## Addendum #1

Project: SB860 – Administration Building – Roof Replacement  
Project Number: 20210256  
Date: March 24, 2025

**1 PARAPET WALL FLASHING**

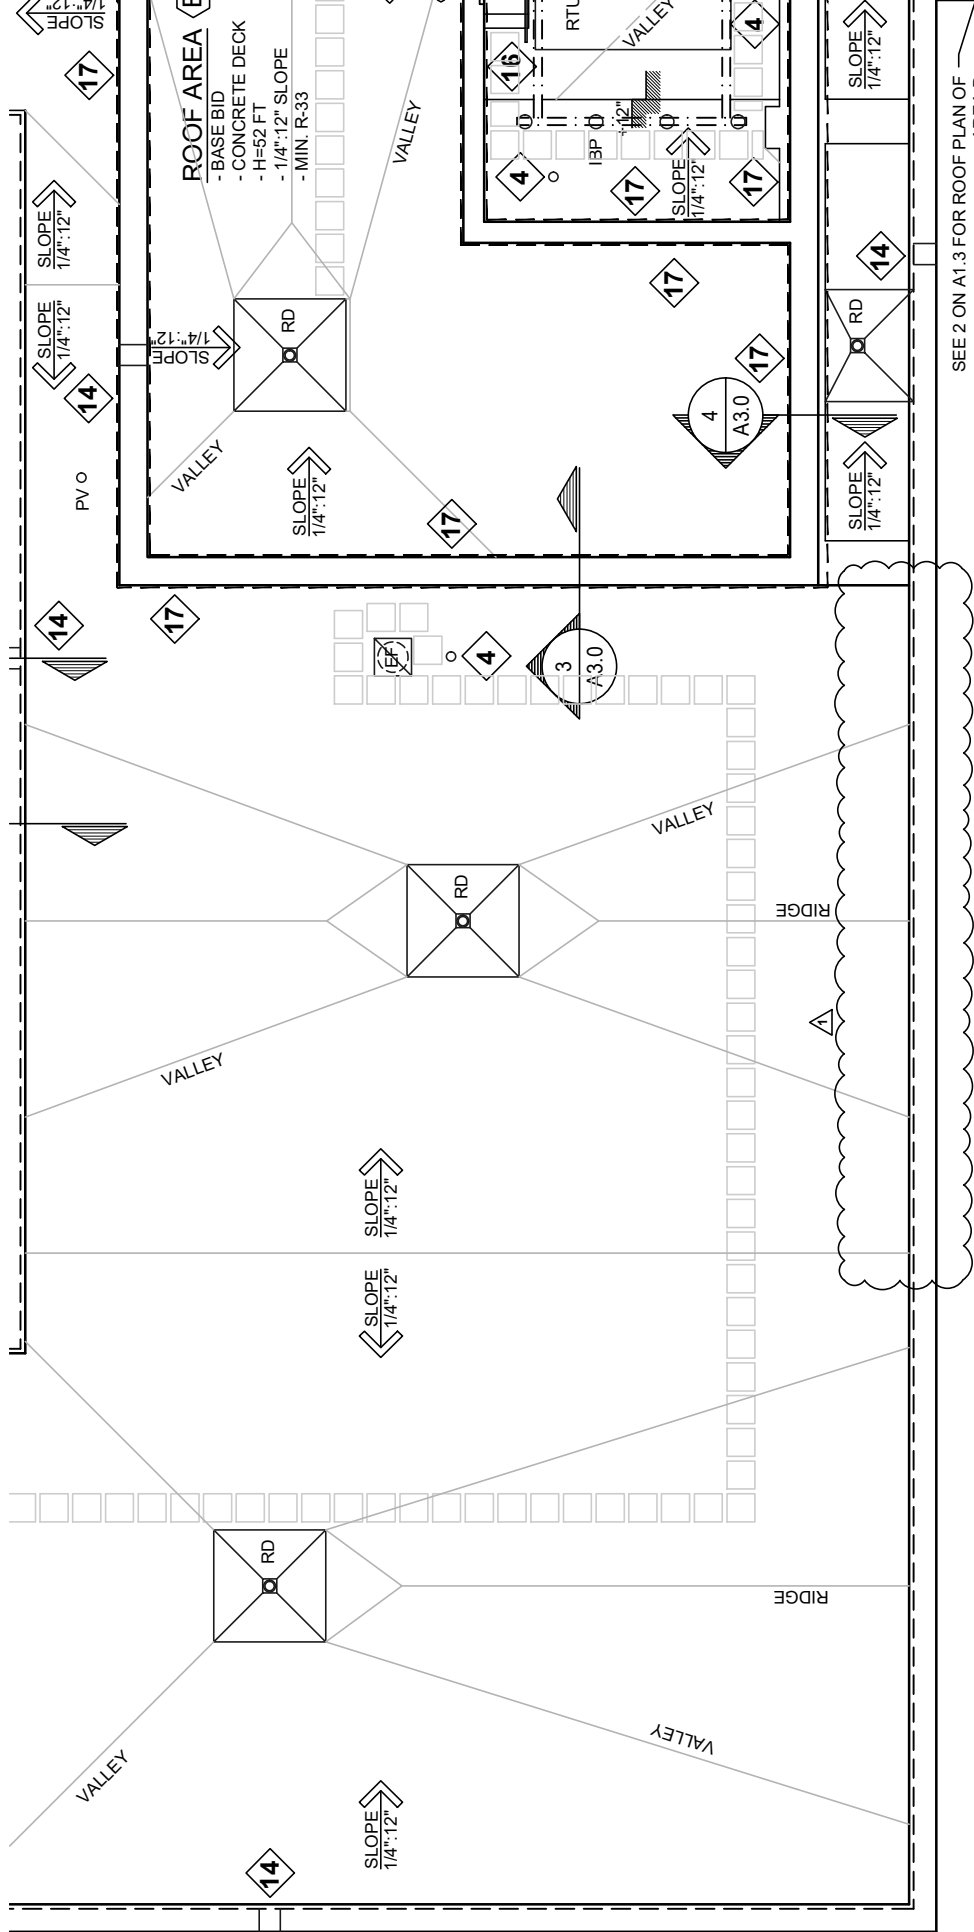
Notes have been added to detail 1 on A3.0 (see the attached). Reuse the existing copper counter flashing below the coping stones to cover the specified termination bar.

EXISTING COPPER THROUGH-WALL FLASHING OR **FUTURE PROJECT** TO INCLUDE NEW THROUGH-WALL FLASHING AND COUNTER FLASHING.

EXISTING COPPER COUNTER FLASHING OR **FUTURE PROJECT** TO INCLUDE NEW COUNTER FLASHING.

SECURE TOP EDGE OF FLASHING USING AN ALUMINUM TERMINATION BAR (WITH LIP) SECURED 12-INCHES O.C., MAX., AND WITHIN 2-INCHES OF EACH END. PRIOR TO TERMINATION BAR INSTALLATION, INSTALL MANUFACTURERS RECOMMENDED SEALANT BEHIND FLASHING WHERE TERMINATION BAR WILL BE PLACED. SEAL TOP EDGE OF FLASHING AND TERMINATION BAR AFTER INSTALLATION.
